October 22, 2015

To: Rapid City Public Works Committee Members

Subject: Request by PAJO Properties, LLC that the City Require Rapid City Regional Hospital to Re-grade its Lots 14-17, Block 1, Rapid River Subdivision to Comply with the State of South Dakota's Planned Jackson Boulevard Drainage System

EXHIBIT 2

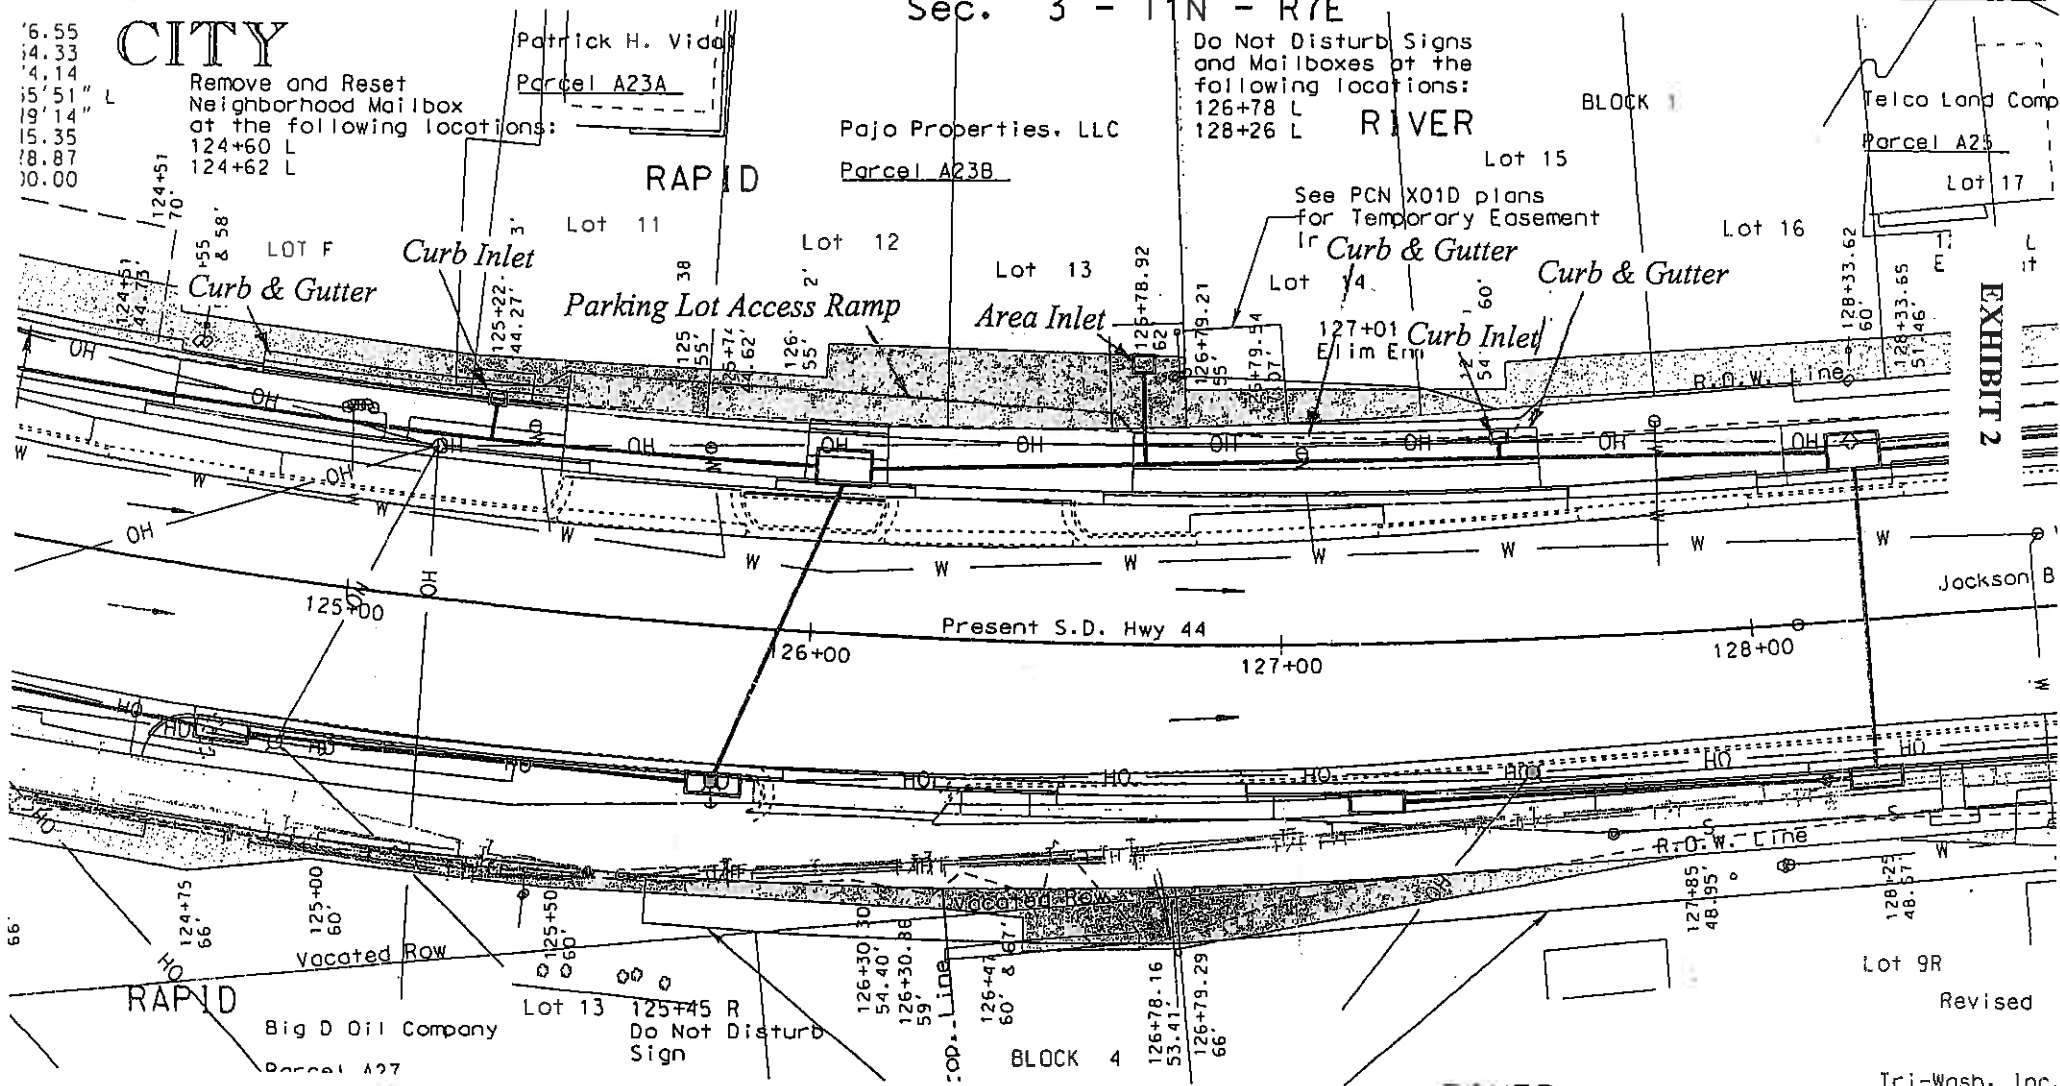
2. DOT's plan was that it would install a curb and gutter system on the back of the sidewalk along the fronts of Lots F-15's parking lots (in its right-of-way), so the parking lots' drainage system could function similarly to most streets' curb and gutter drainage systems [Exhibit 2]. Its plan called for three storm sewer inlets to be installed along this curb and gutter system. It installed these inlets at the fronts of Lots 11, 13, and 15. Lot 11's and 15's inlets were designed to be Type B curb and gutter inlets. Lot 13's inlet was designed to be a Type C area inlet, because it had to be placed along a parking lot access ramp, instead of curb and gutter.

Lots F-16's Parking Lots' Pre-2014 Elevations

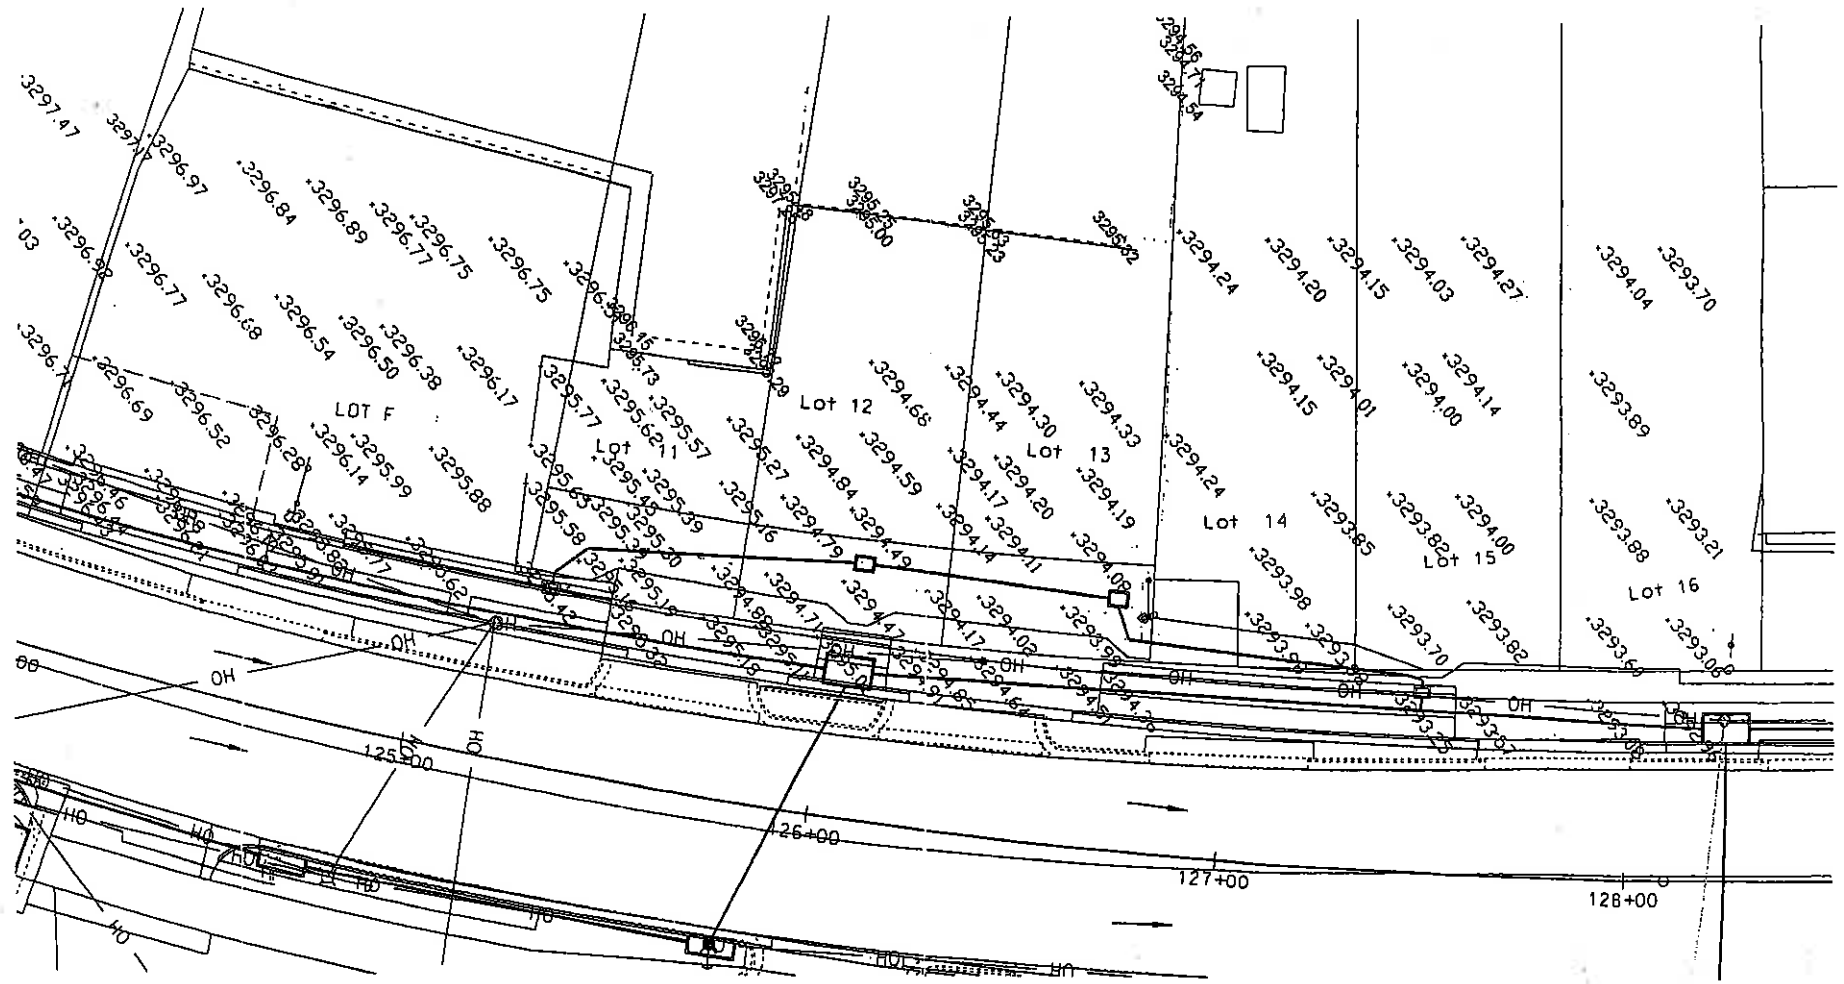
3. DOT's drainageway design assumed its curb and gutter system would tie into Lots F-15's parking lots at their pre-2014 elevations [Exhibit 3]. At these elevations, the drainageway's flows would be able to drain unimpeded from one parking lot to the next.

RCRH's Initial Site Grading and Drainage Plan
Approved by City's Engineering Department

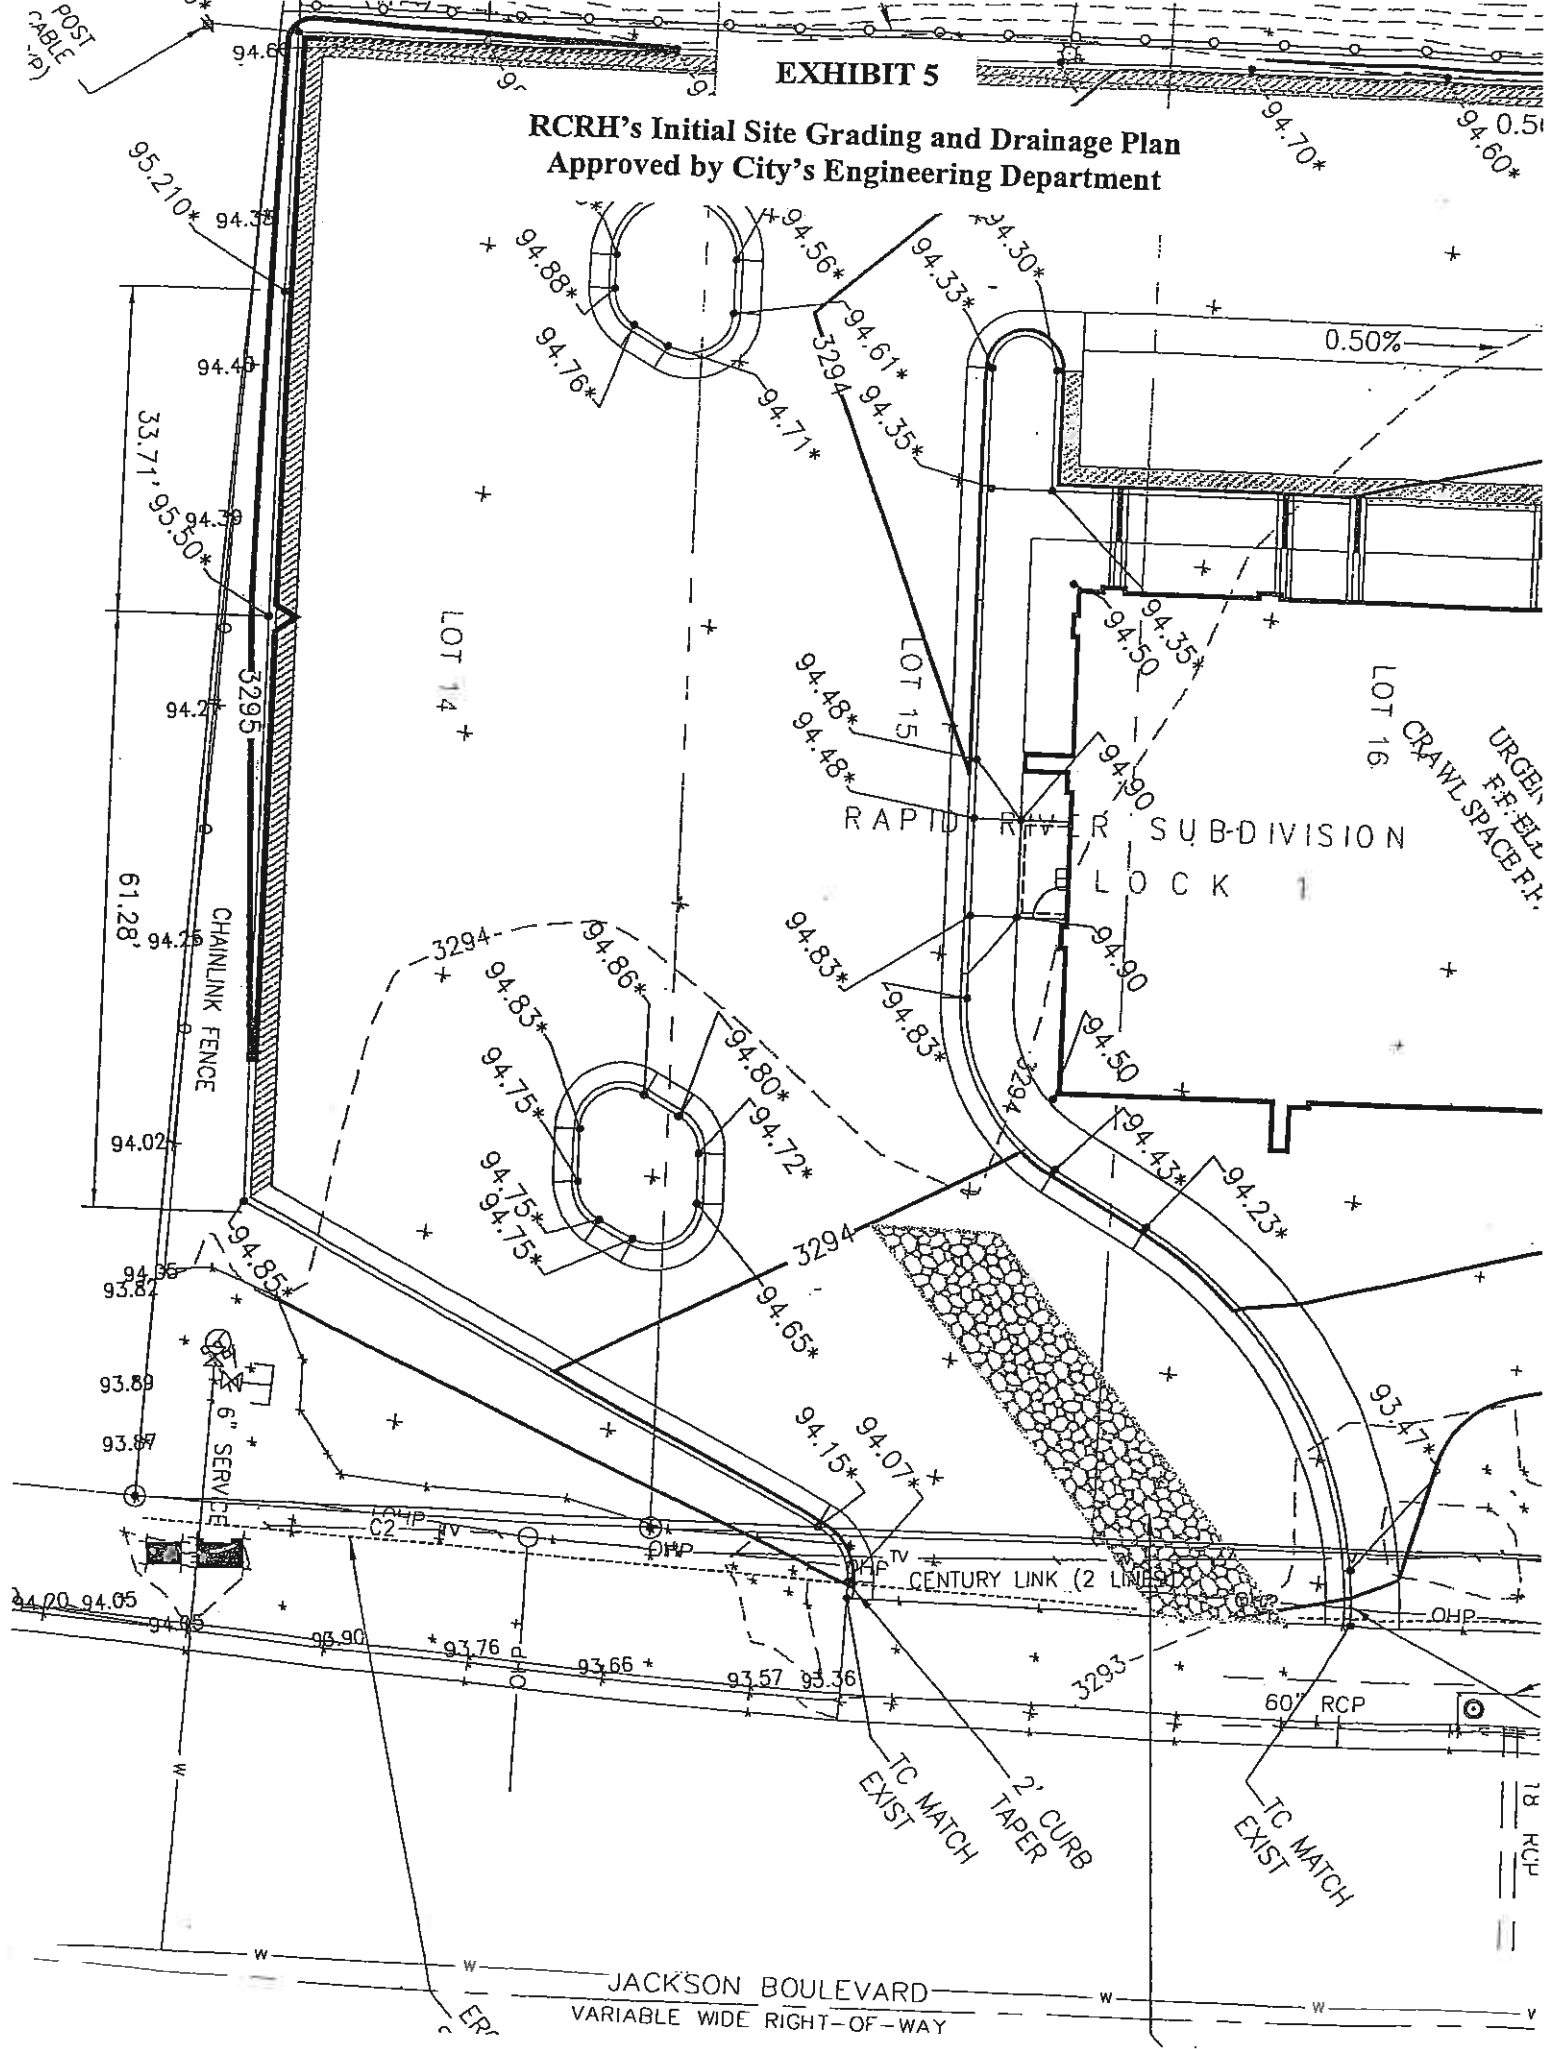
7. In preparing its plans for its building permit, RCRH's architect/engineer (TSP Inc.) totally ignored DOT's street-side drainageway that was supposed to exist at the front of RCRH's lots. Its site grading and drainage plan [Exhibit 5] did not show the drainageway's curb and gutter system that RCRH's parking lot was supposed to tie into. It did not show the drainageway's inlet that DOT had already installed in front of RCRH's Lot 15. What the plan did show was that RCRH was going to raise its property's elevations next to my downstream border to be up to 14" higher than what DOT's drainageway design called for [Exhibit 6B v. Exhibit 6A]. This meant the drainageway would be mostly blocked at my downstream border; and my property now would have to serve as a detention pond for the runoff that was supposed to be able to drain unimpeded onto RCRH's lots. Still, the City's Engineering Department approved RCRH's site grading plan. It approved it on December 20, 2013. Apparently, the two drainage engineers I had been talking to were not aware that RCRH had submitted its plans for a building permit, and a different engineer approved its site grading and drainage plan.

10. When RCRH finally graded and landscaped its southwest corner sometime around June/July 2014, it did not grade it as its architect/engineer had proposed it could be graded at our February 4, 2014 meeting. It did not even grade it as it showed it would in its site grading and drainage plan submitted for its building permit. It graded it instead to have even higher elevations than its site grading and drainage plan showed [Exhibit 6C v. Exhibit 6B]. This meant the drainageway would now be blocked worse at my property's downstream border.
